Our Ref: 20234

**RE: BONNYRIGG STAGES 8 TO 11  
RESPONSE TO COUNCIL ISSUES**

As requested, please find herein The Transport Planning Partnership (TPPP) response to Fairfield City Council's request for further information regarding the above development. This letter sets out our understanding of the request and responses.

**Figure 3: Fire Appliance Road Width Requirements**

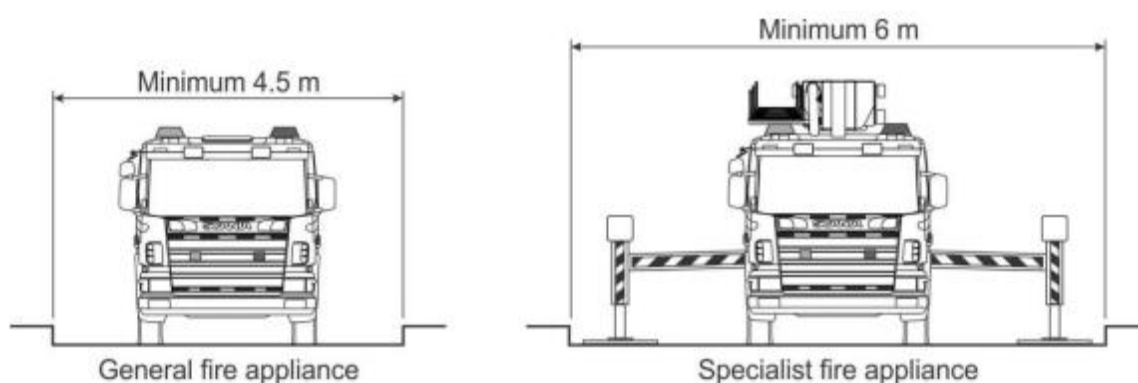
*Council's concerns regarding road widths remain outstanding as it is still considered that the proposed road widths are likely to create conflict with emergency and service vehicles. The proposed road widths for all roads shall be reconsidered, including the 8m laneway intended to service the two medium density development lots. Council also notes that the Concept Plan approval includes streetscape sections for each road type, which will need to be adhered to.*

The NSW Fire and Rescue – Guidelines for Fire Brigade Vehicles and Crew provides guidance on road width required for fire trucks. It specifies minimum widths of 4.5m for general fire appliances and 6m for special appliance. A local low-density area should only need access for general fire appliances. These vehicles should easily be accommodated on 8m wide roads even with parked vehicles. Further we are not aware of any issues being raised about the existing roads that are 8m wide.

Figure 4: Indicative Driveway Locations

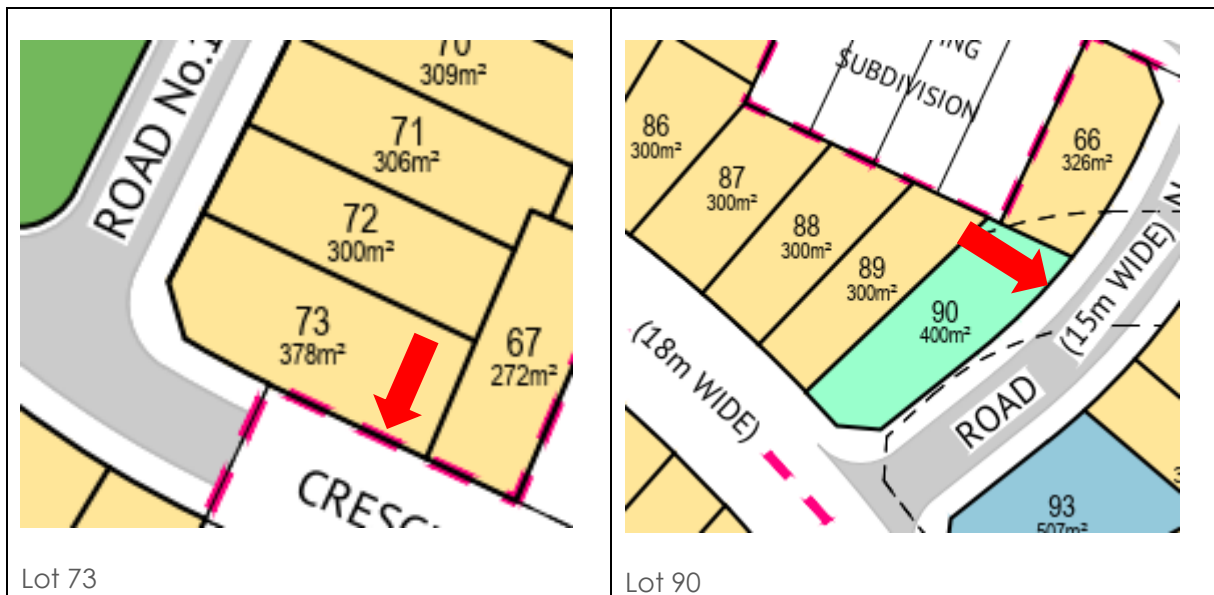
*Australian Standard 2890.1.3.2.3 states that Category 1 entrances on sub-arterial, collector or local streets shall not be located closer than 6.0m from the kerb tangent. It is advised*

*that the proposed driveway locations of lots 15, 16, 62, 66, 69, 73, 90 and 314 do not meet this standard and shall accordingly need to be considered. Please note that should the driveways be relocated to the secondary frontage, it shall need to be demonstrated to Council that future dwellings are capable of complying with the relevant controls within Section 5 of the Bonnyrigg Masterplan 2011 and the visual appearance of the development will remain of a high quality.*

Council has identified that some lots would have restricted locations for driveways as the driveways would be located too close to the corner of intersections. In particular lots 15, 16, 62, 66, 69, 73, 90 and 314 are of concern.

Australian Standard AS2890.1 stipulates that driveways category 1 and 2 cannot be located within 6m of the TP point. However, it also states that for domestic driveways this does not apply to driveways opposite the entering road (AS2890.1 cl 3.2.3).

The lot layouts have been modified and a review of the updated plan indicates that all lots would now be able to provide driveways 6m from the TP points of intersections with locations moved to side streets. Indicative driveway locations on the subject lots are shown in Figure 4.
